SEWAGE DISPOSAL SYSTEM  
MARYLAND STATE DEPARTMENT OF HEALTH

HOWARD COUNTY

ADDRESS 6971 Mink Hollow Road, Ellicott City, Md.

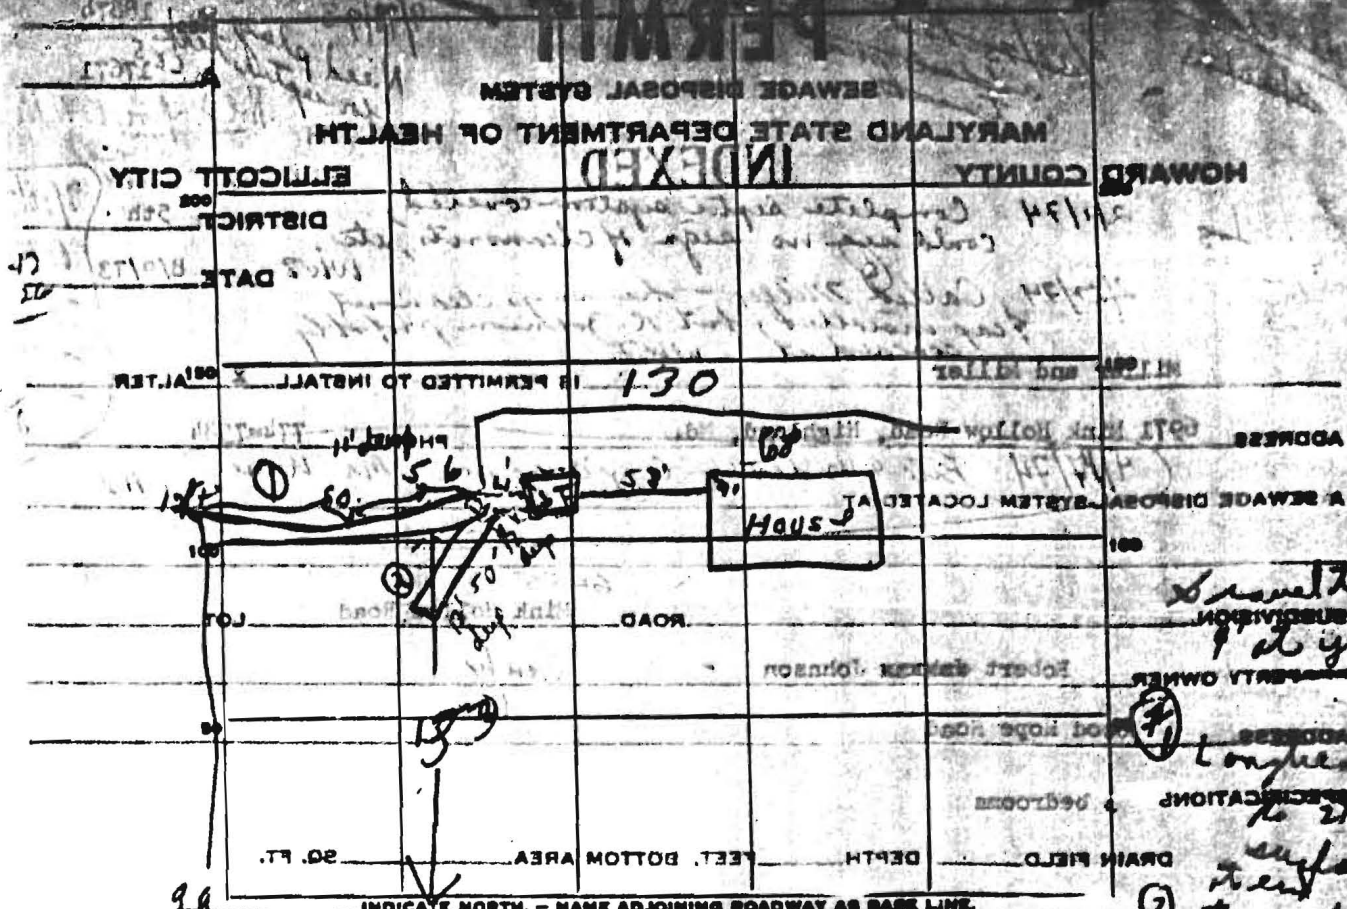
2/1/74 Complete septic system covered, could see no sign of cleanouts, etc.

2/20/74 Called Miller - he says cleanout cap installed, but R. Johnson probably covered it. WVZ

8/20/73 - System in wrong location - need  
 reflect. DUM  
 8/28/73 Trench added to wood road - 12'  
 deep from  $\gamma$  to end near road N. Permit Note  
 location not in area called for! No Septic Tank in "CBS."  
 9/10/73 Part 1 - Top for clearance at Septic Tank not on at  
 location, CBS. See note circled in red on Part 1

SEWAGE DISPOSAL SYSTEM

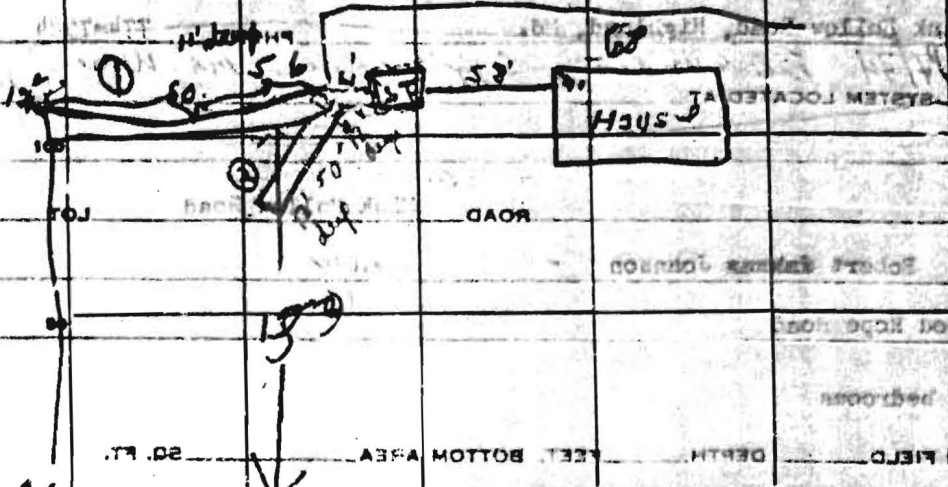
8/20/73 - system in wrong location - needs

relocate. D.M.W. extended into road

8/28/73 - To add 2 more trenches and 1 more pipe to

connection, C.B.S.

8/28/73 Trench added to road road - 12'

deep from 4 to end near road. No permit Note

system not in use called for. No Septic Tank in C.B.S.

9/10/73 Partial - Top for cleanout at Septic Tank not on at

connection, C.B.S.
